Welcome Break

Directional Signing for Motorway Services Proposals

Technical Note – Amendment with Additions Scenario

110705-PEF-XX-XX-TRP-H-000003

Ref	Approx Sign Location	Existing sign face image	Intervention detail
PRLS04 (EXLS2)	M69 northbound Exit slip road appropriate lane sign		Option 1 Patch with “Serv” legend 125mm x-ht Option 2 New sign face PRLS04 to be mounted on existing posts. Option 2 New full assembly PRLS04 to replace XEXLS2

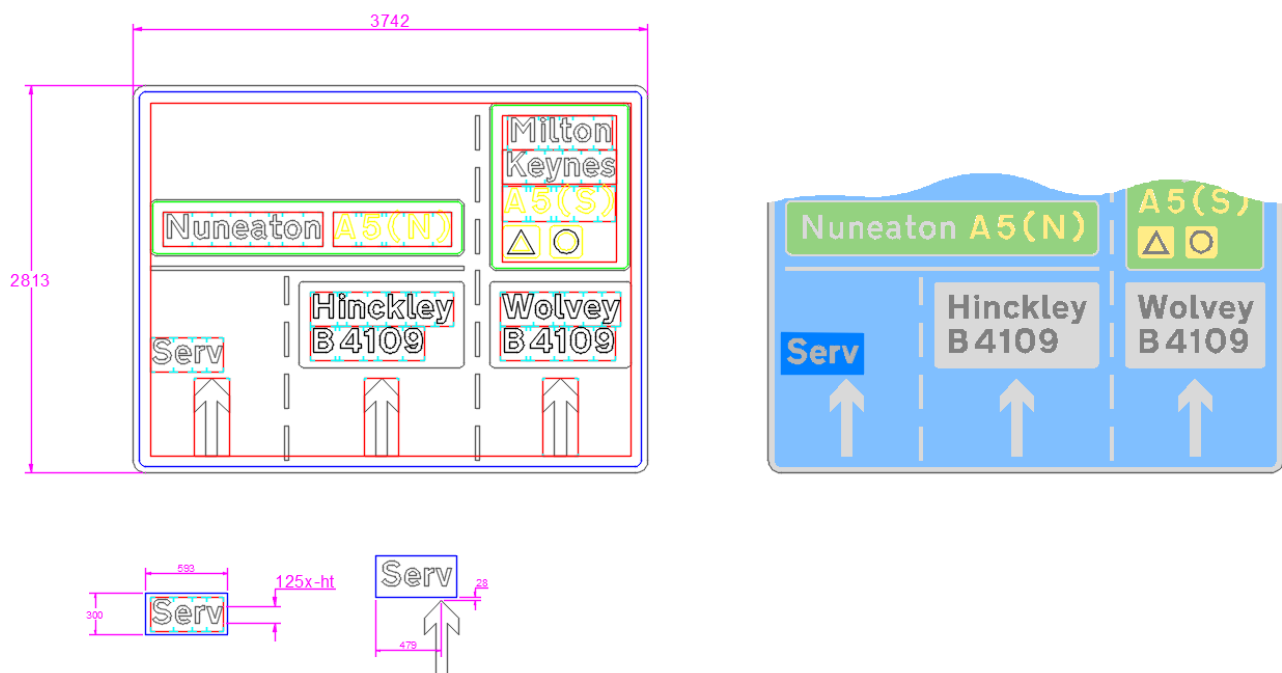
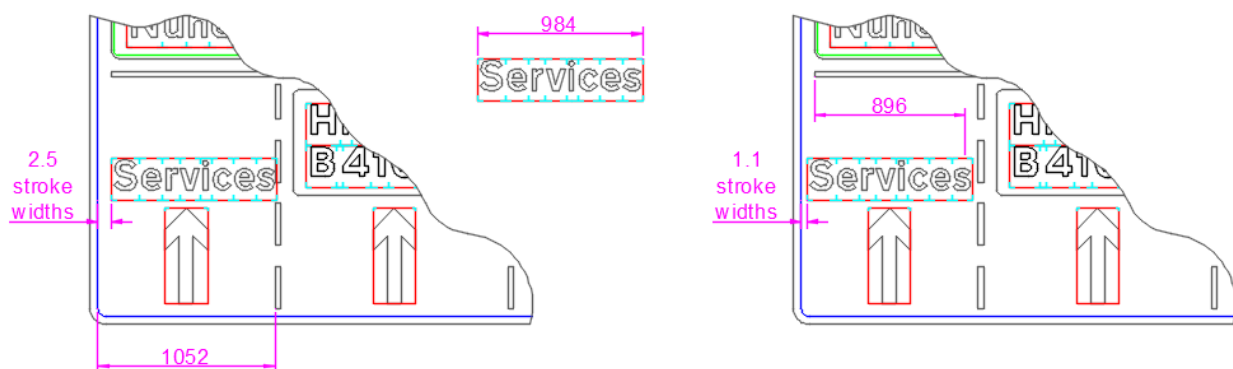
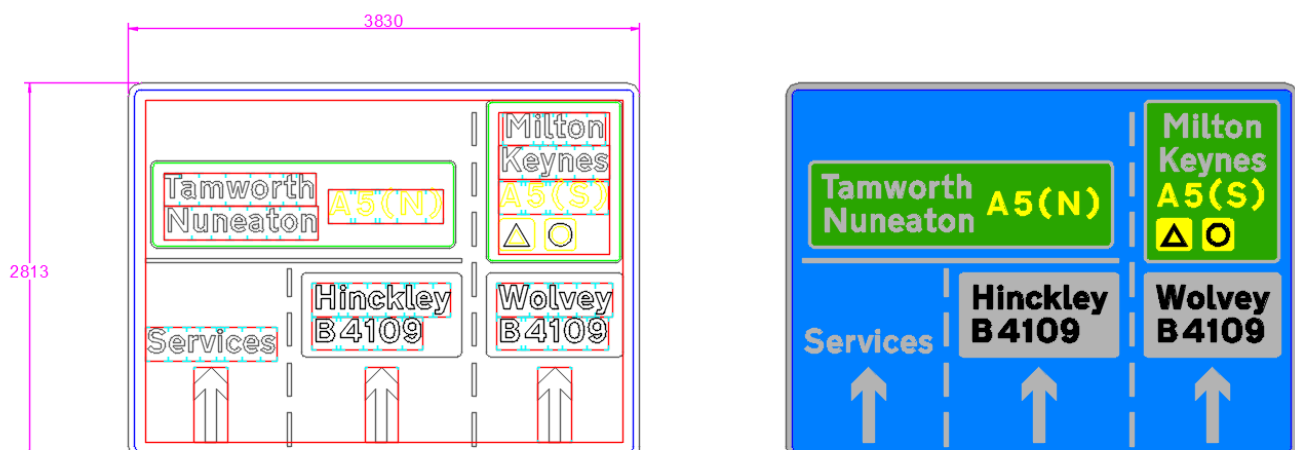
National Highways comments suggest that there may be concerns with regard to the addition of a patch incorporating the legend “Serv” given that there may be differences in the retroreflectivity of newer and older materials contained within the same sign face. The sign face appears to have been replaced previously at some point between Nov 2020 and May 2021 however, and it is therefore assumed that the sign will be in a good condition given its age.

An assessment of the existing sign face assumes that the sign has been designed following all of the set-out rules from TSM Ch7 with an x-height of 125mm (appropriate lower value for an 85th percentile approach speed between 41 and 50mph).

Subject to the agreement and approval by National Highways it may be possible to therefore overlay a portion of this existing sign with an adhesive patch of the same colour containing the appropriate legend “Serv” rather than necessitating a full sign face replacement.

The width of the left-hand lane is calculated proportionately from the other sign elements (at 1052mm inside edge of border to lane marking symbol, 896mm remaining with 2.5sw spacing to other sign elements).

The width of tiled legend “Services” at an x-height of 125mm is 984mm.

Including the full worded legend “Services” would likely be clearer to approaching drivers. However, as calculated the left-hand lane is likely insufficient to enable the full worded legend “Services” to be accommodated within the available width. This would not be possible whilst fully adhering to the regulations.

The full worded legend “Services” could never the less be included in a patch, however this would require either:

- The patch being manufactured at an x-height smaller than the main sign x-height (this is not permitted by the regulations however and would need to be agreed by NH), or
- By locating the legend “Services” so that it is centered above the lane arrow. This would however result in the tiled legend being placed at only 1.1 stroke widths from both the inside edge of the sign border and the lane marking symbol, rather than the set 2.5 stroke widths and would also need to be agreed by NH.

It may be preferred to install a full replacement sign face on the retained existing post arrangement. Initial calculations suggest that the existing sign face (at an x-height of 125mm) has overall dimensions at 3742w x 2813h.

A replacement sign face designed following all of the set-out rules from TSM Ch7 also with an x-height of 125mm (appropriate lower value for an 85th percentile approach speed between 41 and 50mph) and incorporating the full worded legend “Services” would produce a sign with overall dimensions 3830w x 2813h.

A sign face at 3830w x 2813h is roughly equates to a face 2.5% larger overall than the existing sign face. By reducing the sign x-height to 123mm however, the overall dimensions drop to 3742w x 2813h which is around 1% less than the existing sign area.

Subject to the agreement and approval by National Highways it may therefore be possible to provide a replacement sign face which reuses the existing 2no. RHS post arrangement. Contingent upon confirmation, an assessment of the existing signposts may determine whether a replacement sign face can be accommodated within the capacity of the existing post load.

A replacement sign face also provides opportunity to amend the displayed information at this location to include “Tamworth” to correlate with upstream signs.

Ref	Approx Sign Location	Existing sign face image	Intervention detail
PRLS06 (EXLS11)	M69 northbound Exit slip road primary ADS sign		Option 1 Replacement sign face at 125mm x-ht mounted on existing posts Option 2 Full new sign assembly PRLS06 new sign face and new post/s and foundations

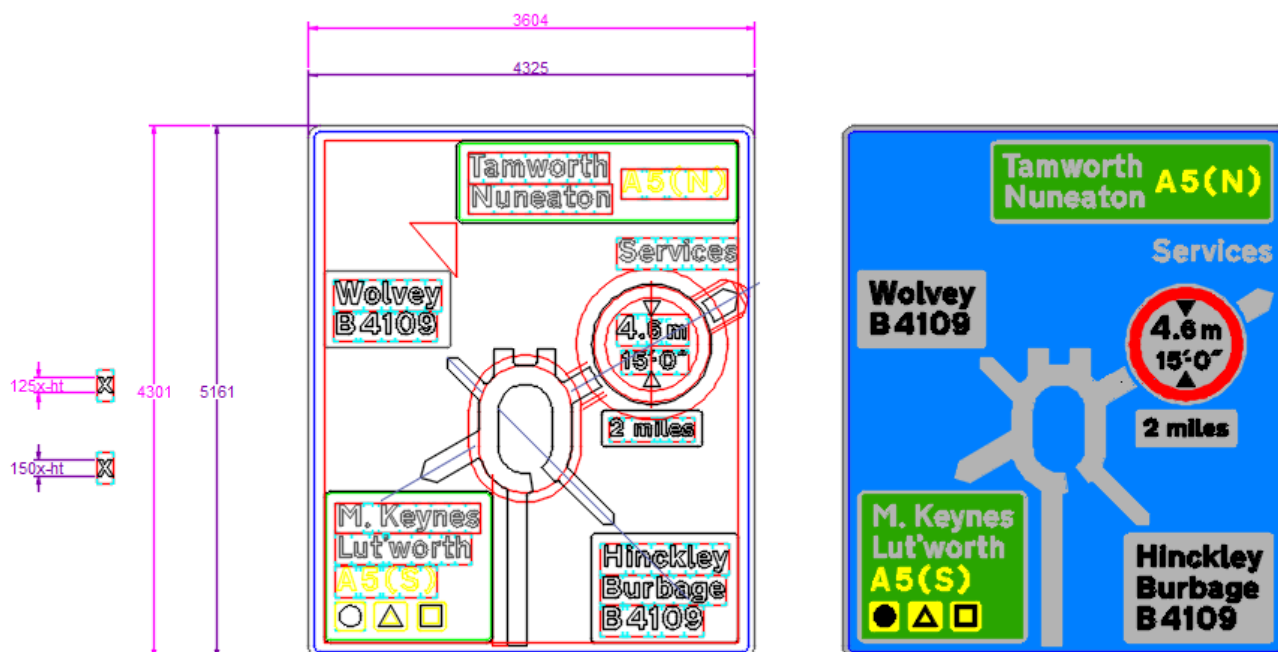
A new replacement ADS sign face is proposed to replace EXLS11 to incorporate the legend “Services” and to direct drivers to the new service area at Hinckley from the roundabout.

It is proposed to install a new sign face to replace the existing ADS onto the existing 2no. rectangular hollow section posts. The new sign face layout design should be such that the proposed overall area of the sign does not exceed the existing sign dimensions so that no additional load will be exerted on the post and foundation assembly, thereby negating the need to fully replace. The existing sign dimensions require confirmation.

A replacement sign face will also provide opportunity to correct existing errors with regard to the incorporated tactical diversion symbols. The tactical diversion symbols should be associated with the relevant route number to be followed and contained within the relevant panel.

The proposed sign face layout is calculated to likely be taller than the existing sign face. It may be possible to mount the proposed replacement sign face at a slightly lower height than the existing sign to accommodate the additional sign face height. Contingent upon confirmation, an assessment of the existing signposts may determine whether a replacement sign face can be accommodated within the capacity of the existing post load.

The slip road is national speed limit on approach to the roundabout. An x-height of 150mm would be more appropriate for this sign on the assumption that the likely 85th percentile vehicle speed on approach to the sign is at or between 51 and 60 mph given road geometry and expectation of drivers slowing having exited the motorway main alignment (refer to TSM Ch7 Appendix E – row 5, column 3, lower value). Contingent upon confirmation, the existing sign proportions suggest an x-ht of 125mm has been used on the existing sign face however.

Ref	Approx Sign Location	Existing sign face image	Intervention detail
PRLS07 (EXLS12)	M69 southbound Exit slip road appropriate lane sign		Full new assembly New sign face and new post/s and foundations PRLS07

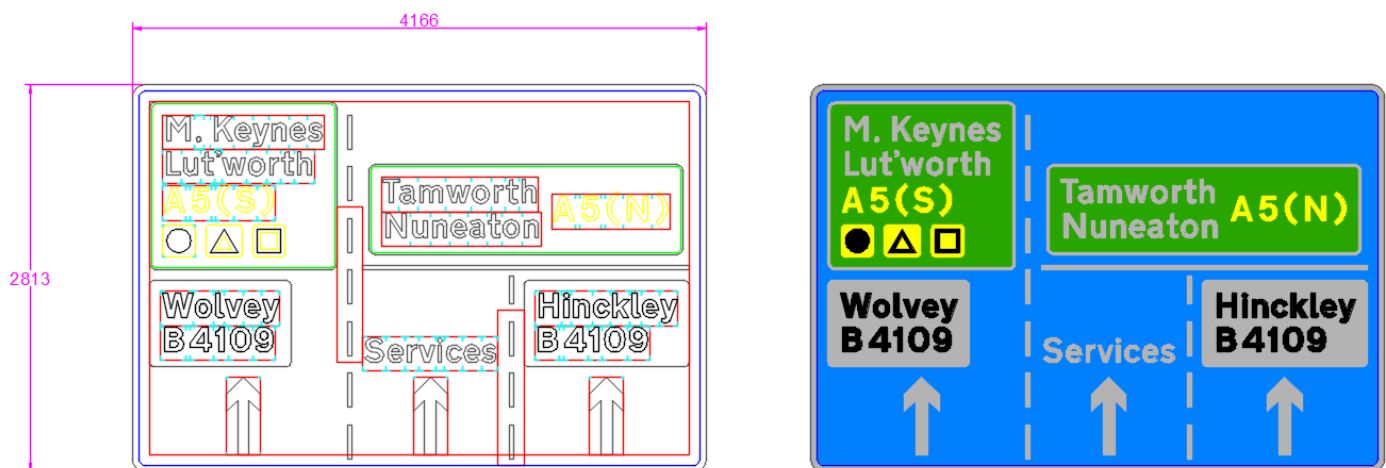
National Highways comments suggest that there are concerns with regard to the addition of a patch incorporating the legend “Serv” to this sign both due to its age and general poor condition. There is concern that differences in the retroreflectivity of newer and older materials contained within the same sign face may be more apparent to drivers.

Existing posts appear to be rusted and as such their performance and life span may be negatively affected. It is therefore proposed to install a full replacement sign assembly.

A full replacement assembly also provides opportunity to amend the displayed information at this location and include both “Lut’worth” and “Tamworth” to correlate with upstream signs.

It is noted that the existing roundabout ADS sign (EXLS9 to be replaced by PRLS06) on this approach also displays 3 associated tactical diversion symbols (‘filled circle’, ‘open square’, and ‘open triangle’). This is not consistent with the upstream mainline ADSs however (which indicate only ‘open square’). There is however a “secret sign” located approximately 50m upstream of the ‘100 yards’ countdown marker and this may display other tactical diversion information including ‘filled circle’, and ‘open triangle’ routes to be followed.

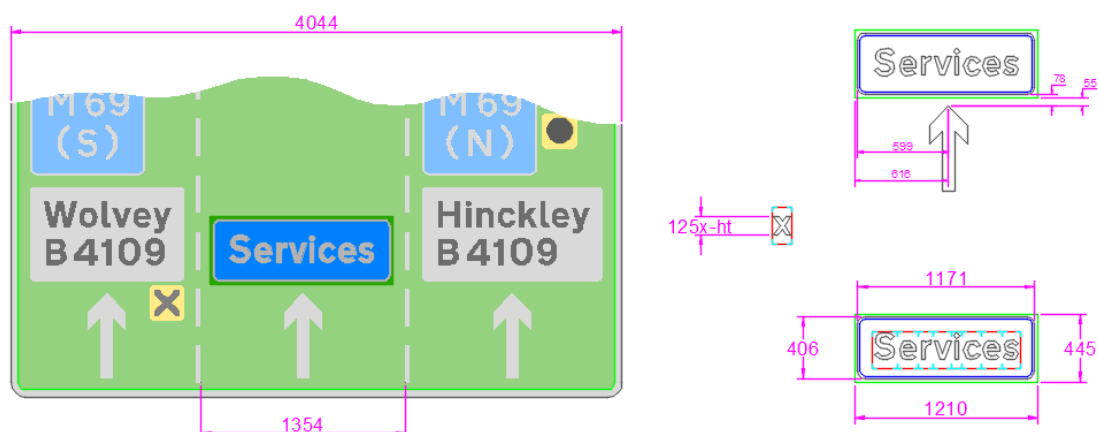
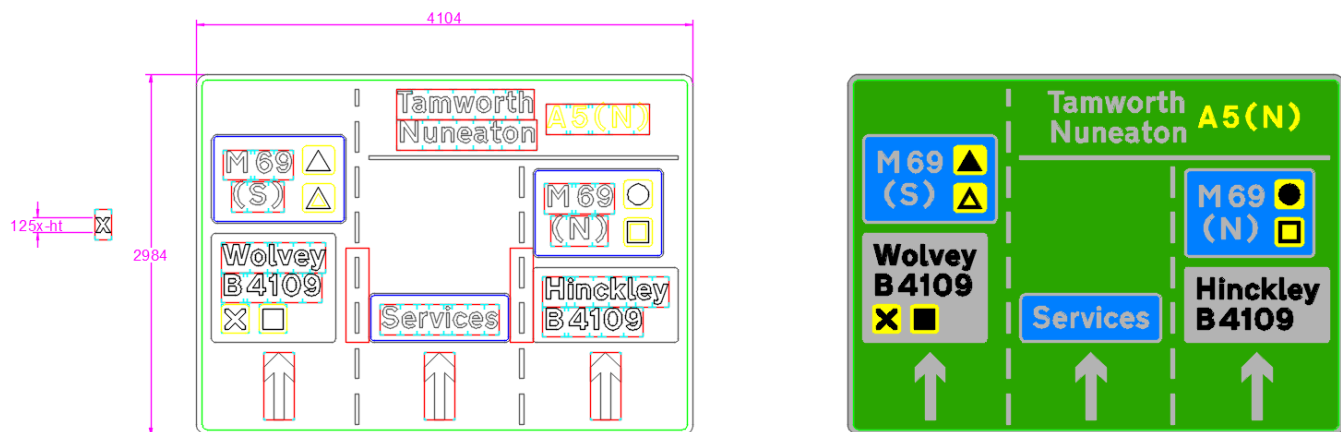
It may be possible to overlay a portion of the existing sign with an adhesive patch containing legend “Services” on a blue panel rather than necessitating a full sign face replacement.

National Highways comments suggest that there may be concerns with regard to the addition of a patch incorporating the panel and legend “Services” given that there may be differences in the retroreflectivity of newer and older materials contained within the same sign face.

Contingent upon confirmation, an assessment of this existing sign EXLS5 condition and with the assumption being that the plate design is mostly in-line with the relevant guidance and dimensions from TSRGD and TSM, the central lane width on the existing sign should be sufficient to accommodate a retrofit patch incorporating a white-on-blue panel including the legend “Services”.

The sign dimensions and resultant width of the middle lane is an approximation; however it is likely that the middle lane is wide enough to accommodate the full legend “Services” on a panel.

A replacement sign face would however provide opportunity to amend the contained errors with some sign elements displayed. It appears that the sign has at some point been retro-fit with tactical diversion symbols. The tactical diversion symbols should be associated with the relevant route number to be followed and contained within the relevant panel. Amending this on a replacement sign face would also provide continuity on signage through and on approach to the junction.

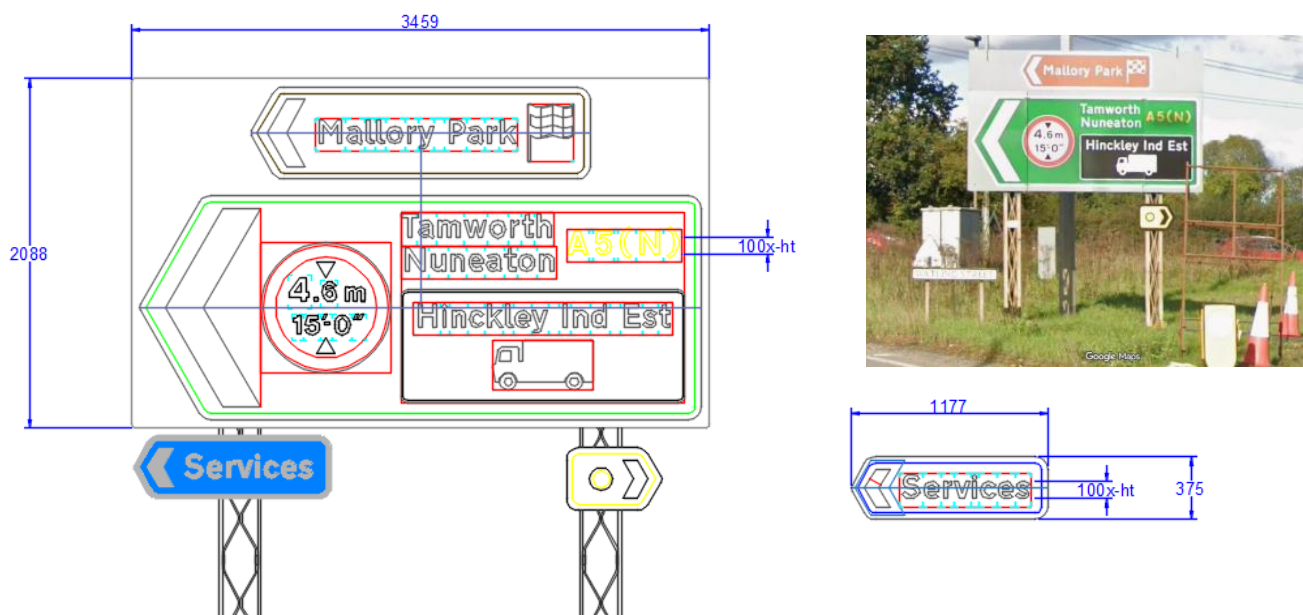
It is proposed to install a separate new sign onto the existing directional sign assembly located on the nose of the central splitter island at the A5 northbound exit from the roundabout.

An assessment of the existing sign assembly proportions as viewed on Google Streetview would suggest that the signs are installed with an x-height of 100mm. This assessment is based on the assumption that the existing signs have been designed following most or all of the set-out rules from TSM Ch7. This would need to be confirmed prior to new sign fabrication.

Ref	Approx Sign Location	New sign face	Intervention detail
PRSS01	A5 Watling Street eastbound. To be located approximately 1500m west of the new services access junction.		New sign assembly PRSS01. New sign face and new post/s and foundations.

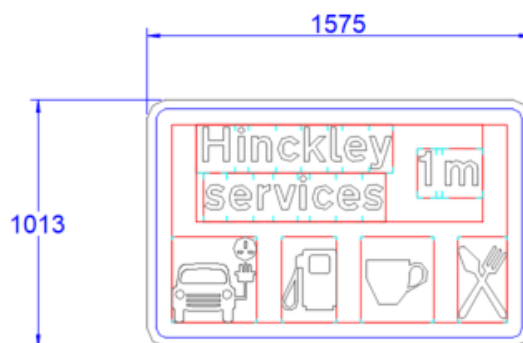
The posted speed limit on A5 Watling Street travelling eastbound from the roundabout at Logix Park on approach to the site is 40mph. An x-height of 100mm would therefore be appropriate for this sign.

It would be recommended that this new sign be mounted on a passively safe posts given the likely 85th percentile vehicle speed in both directions at this location being at or around 40mph. There is no existing VRS in this location.

Ref	Approx Sign Location	New sign face	Intervention detail
PRSS02	A5 Watling Street westbound. To be located approximately 550m east of the M69 J1 roundabout junction.		New sign assembly PRSS02. New sign face and new post/s and foundations.

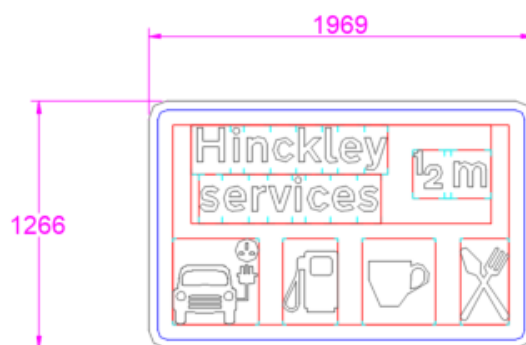
The posted speed limit on A5 Watling Street travelling westbound from the Five Oaks roundabout is 50mph. An x-height of 125mm would therefore be appropriate for this sign.

Add 12no. road marking text at Stretton Baskerville roundabout junction;

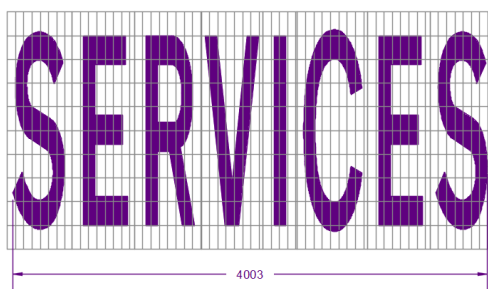
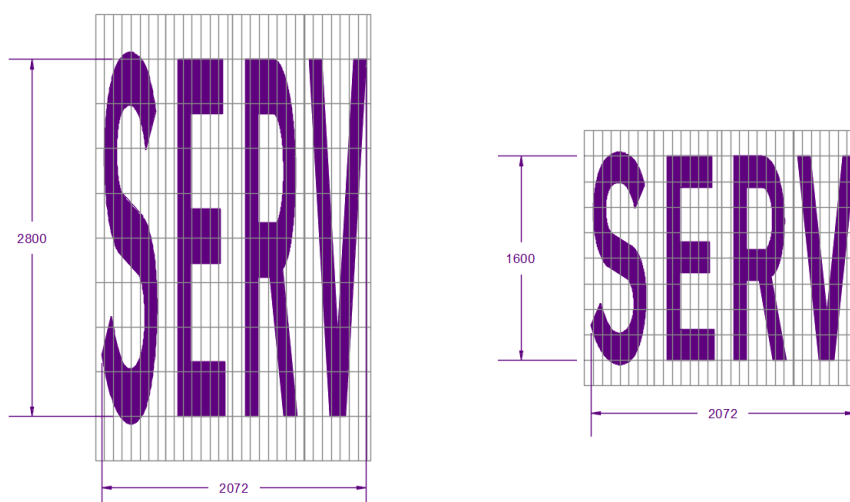
There are 12 noted instances where the addition of an appropriate legend could be laid adjacent to these existing markings to provide drivers with additional lane guidance towards the new MSA at Hinckley.

Two sizes are prescribed for the legend text, 1600 mm and 2800 mm. The smaller size is intended to be used where the speed limit is 40 mph or less. The larger size is used where the speed limit is more than 40 mph.

As such the application of full legend “SERVICES” is unlikely to be achievable owing to the overall width of the laid characters being 4003mm.

In respect of an applicable abbreviated legend it would be recommended to use legend “SERV” subject to the agreement and approval by both National Highways and the Local Highways Authority.
